Technical Service Bulletin

**MODEL(S)
AFFECTED:****Tennant T7 Rider Scrubber**

SUBJECT:

Potential squeegee lift actuator and/or spring housing failure due to a clearance issue.

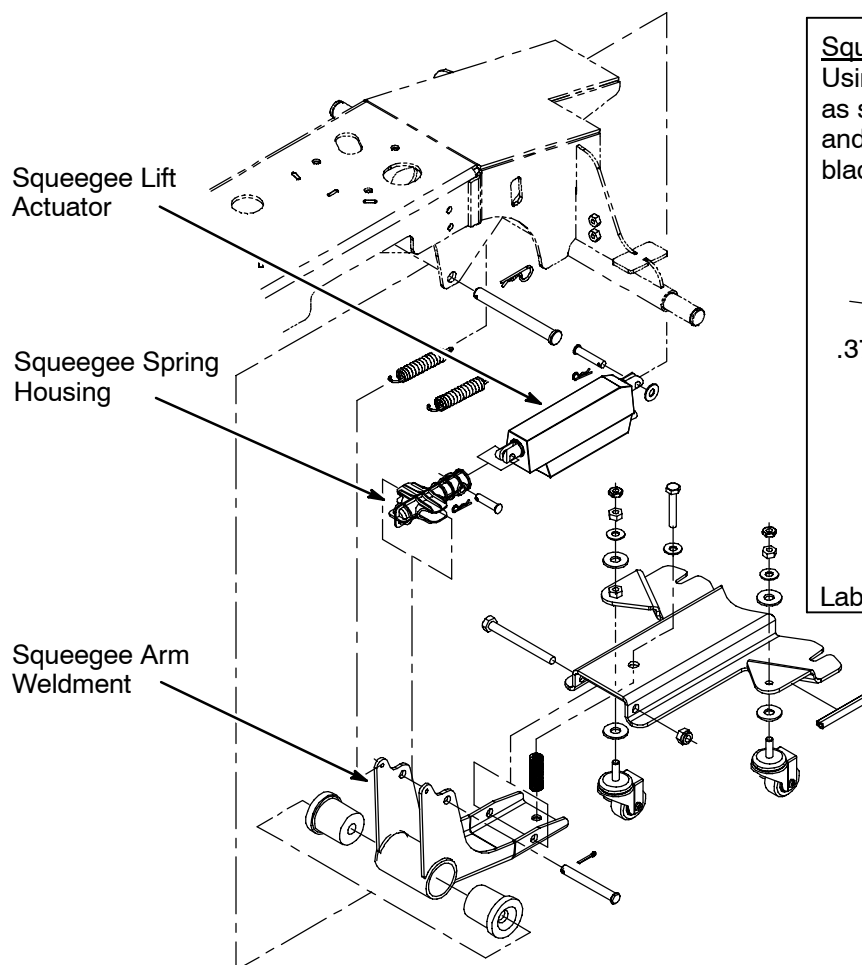
To prevent potential actuator and spring housing failure, the squeegee arm weldment must be modified as described below. The suggested modification will provide proper clearance for actuator movement, eliminating the risk for failure.

Squeegee Arm Weldment Modification:
Using a die-grinder, remove the material as shown. Blow out the metal shavings and touch up the exposed metal with black paint.
